REGIONAL REVIEW NOTIFICATION

ARC REVIEW CODE: R2007271

Name of Proposal: Bolton Mixed Use (DRI #3097)

BOLTON MIXED USE DRI
City of Atlanta
Natural Resources Group Review Comments
June 30, 2020

Stream Buffers

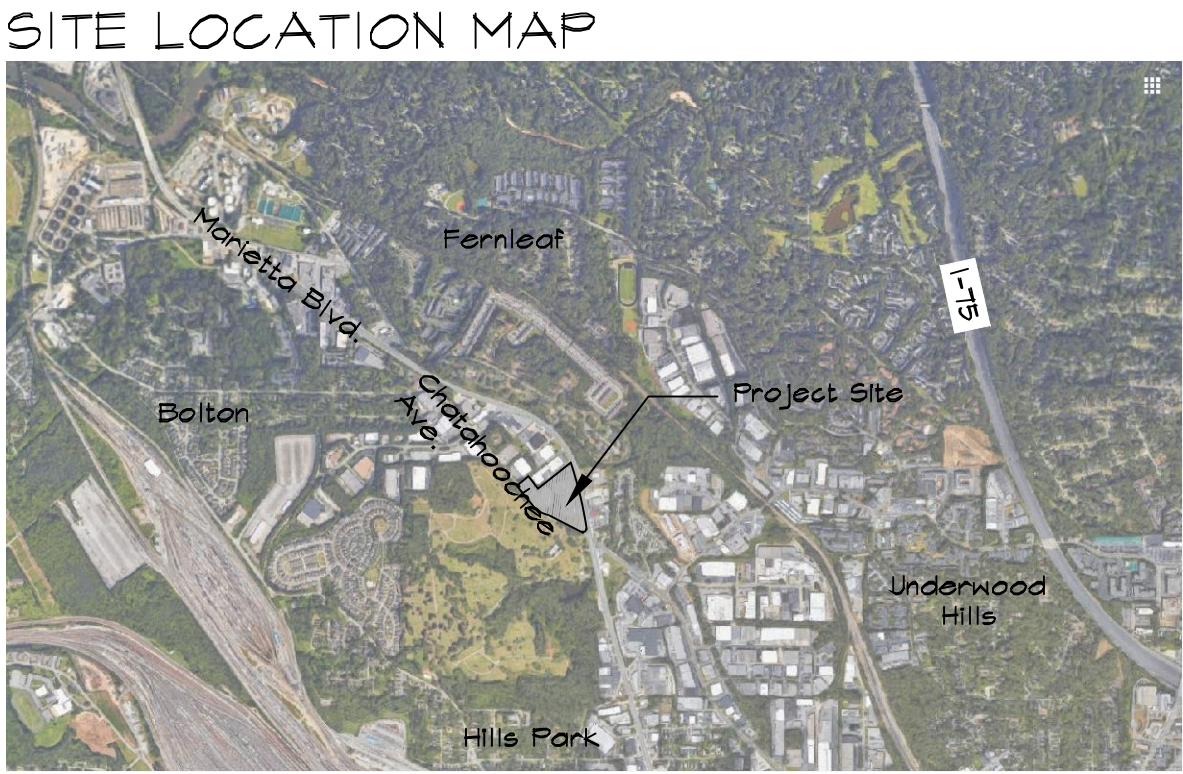
The USGS coverage for the project area shows no streams on or near the property. No streams or other waters of the State are shown on the submitted site plan and no evidence of streams or other waters is visible in available aerial photo coverage. Any unmapped streams identified on the property may be subject to the City of Atlanta's stream buffer ordinance. Any unmapped State waters identified on the property will be subject to the State 25-foot Sediment and Erosion Control buffer.

A SITE PLAN
P-1 SCALE: 1"=40'

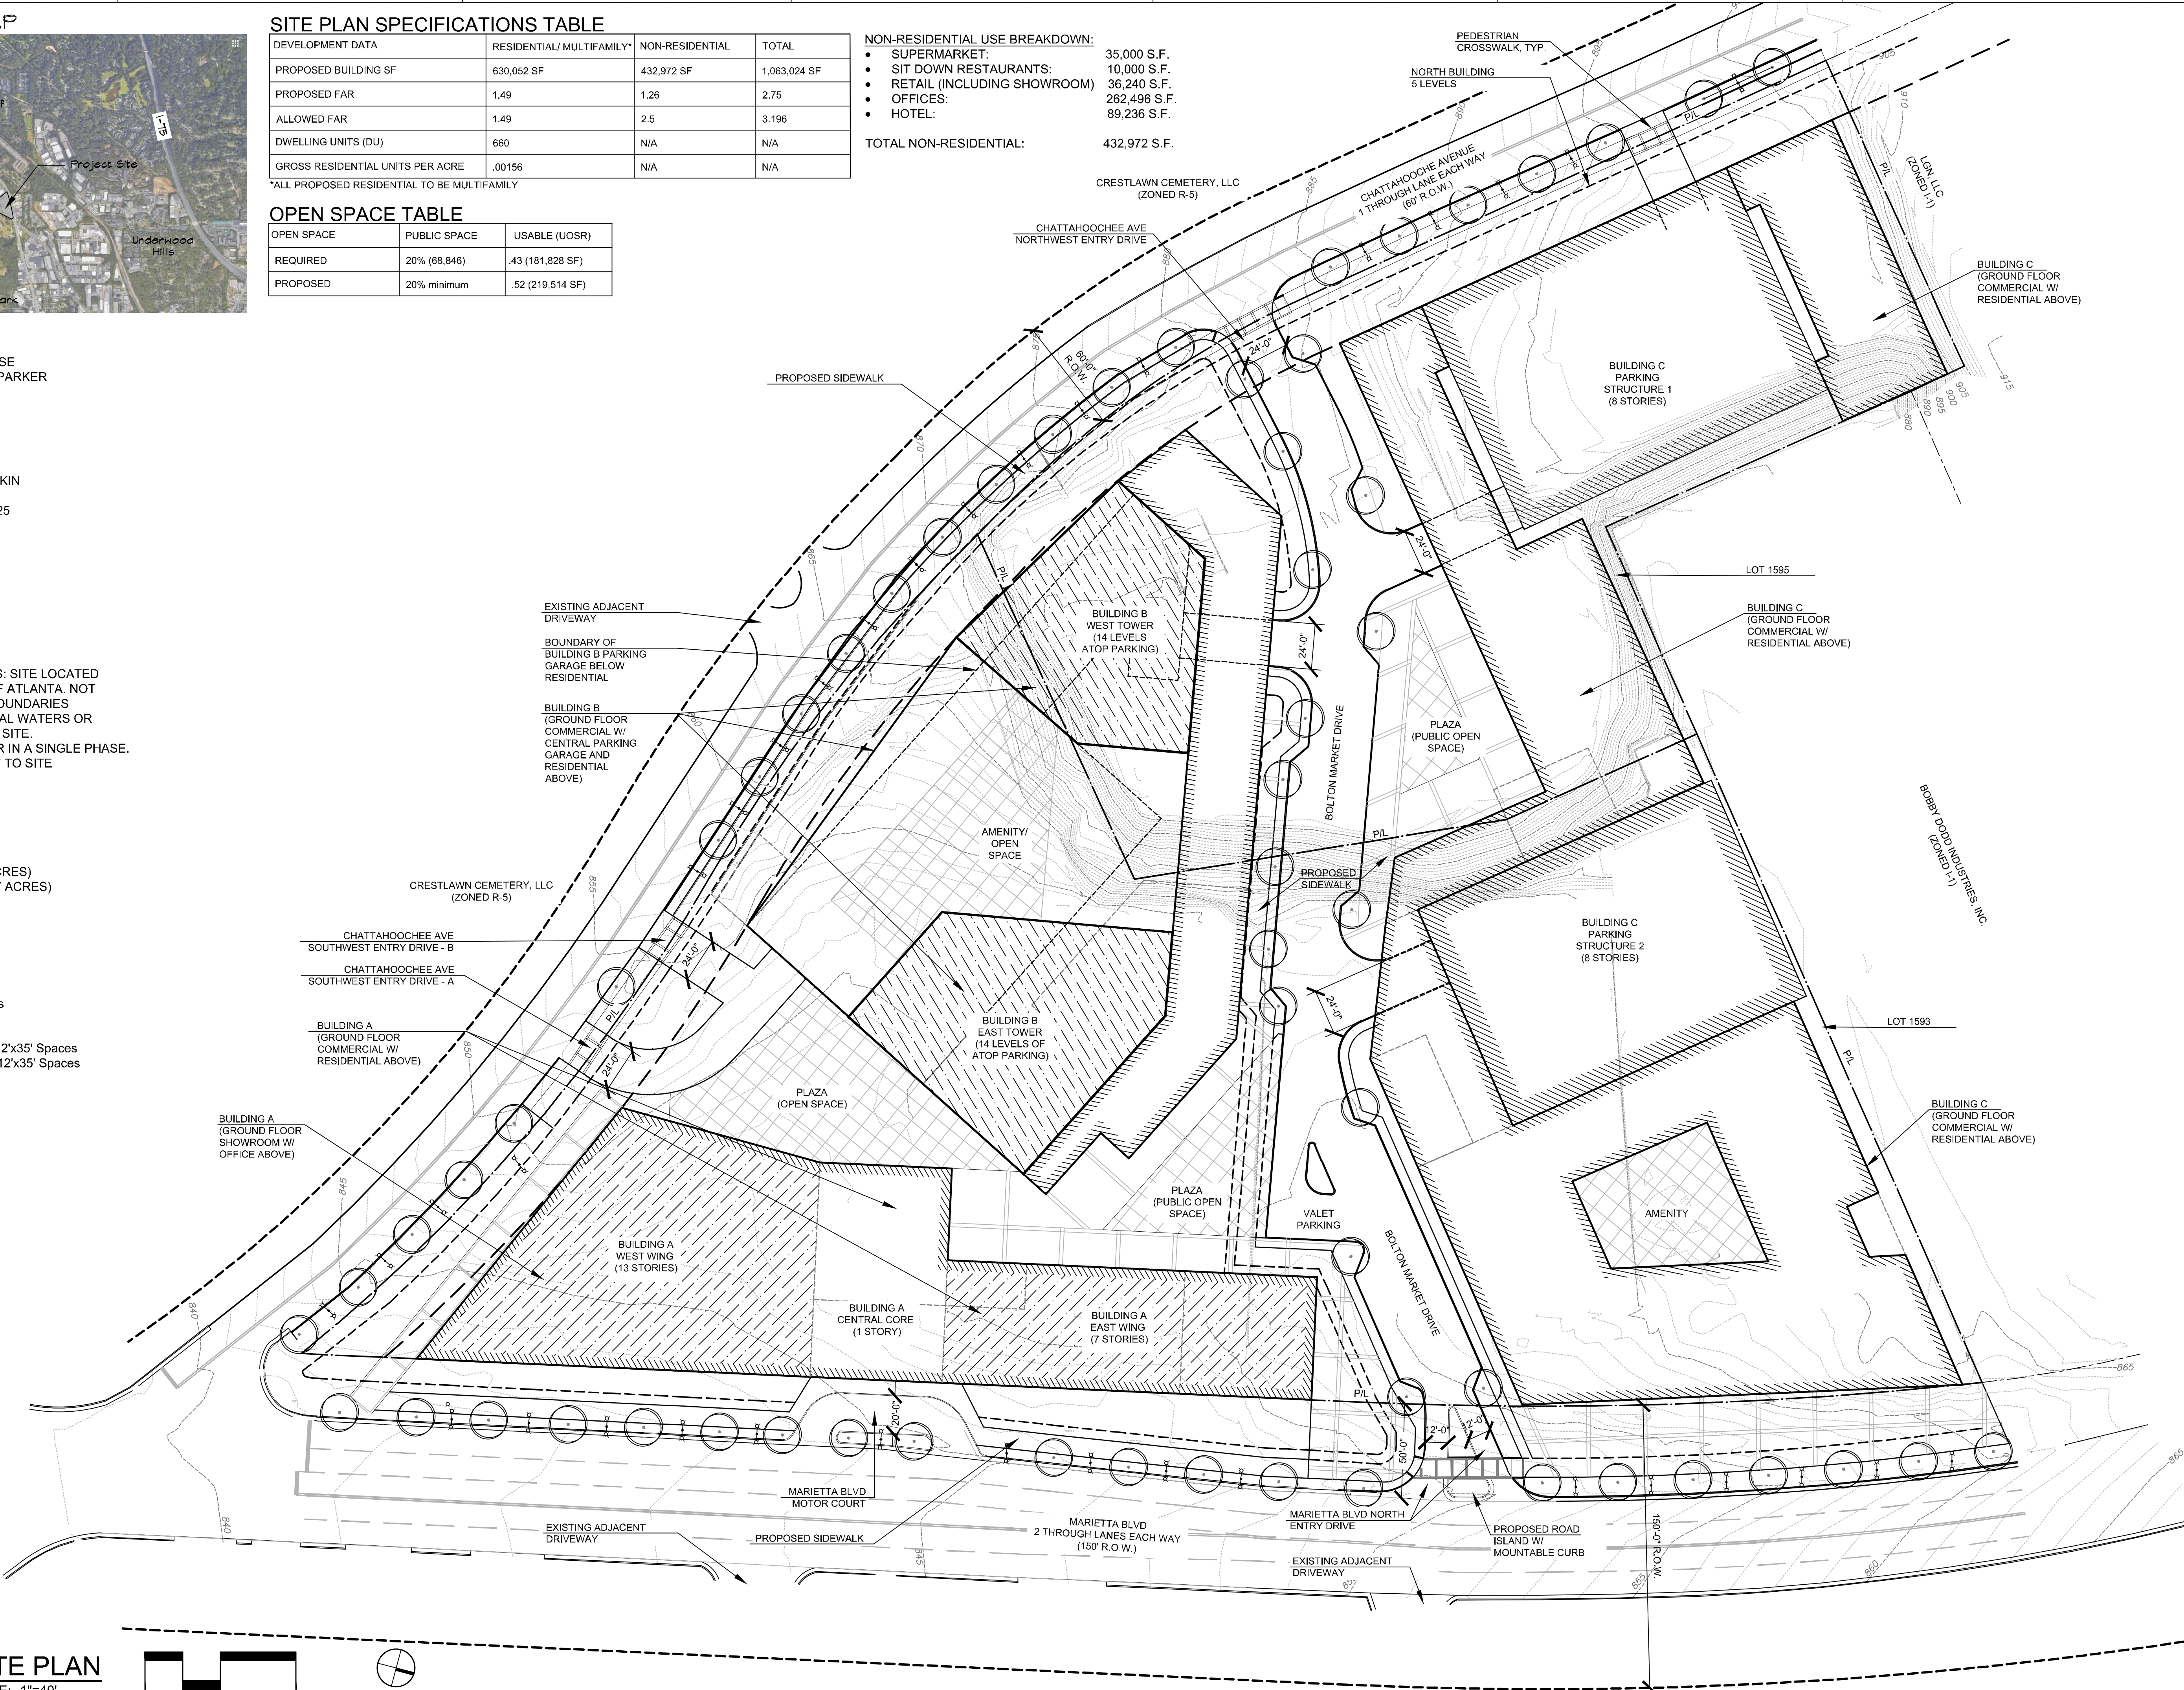
During the Pre-Review meeting on April 22, 2020, there was discussion about whether two driveways (Southwest Entry Drives A & B) on the Chattahoochee Avenue side were necessary because they are close together and introduce unnecessary pedestrian conflicts. The submitted site plan still shows these two driveways, but further analysis should consider whether the access can be accomplished with one. There was also discussion about the motor court shown on Marietta Boulevard, which can be useful for ride-hailing services and deliveries, but has the potential to intrude on the pedestrian space. The driveway should be designed in such a way that prevents drivers from exiting Marietta Boulevard at high speed and maintains ample ADA-accessible passage for pedestrians.

The project could further support The Atlanta Region's Plan in general if it incorporated other aspects of regional policy, including green infrastructure and/or low-impact design (e.g., rain gardens, vegetated swales, etc.) in parking areas and site driveways, and as part of any improvements to site frontages. There appear to be many opportunities for incorporating this infrastructure in the projects public plazas and internal street.

Proposed building about adjacent parcels prohibiting inter parcel connectivity. Adjacent parcels can be accessed from local roads.

The site plan depicts pedestrian facilities adjacent and internal to the site.

The site plan depicts proposed sidewalks internal and adjacent to the proposed site.
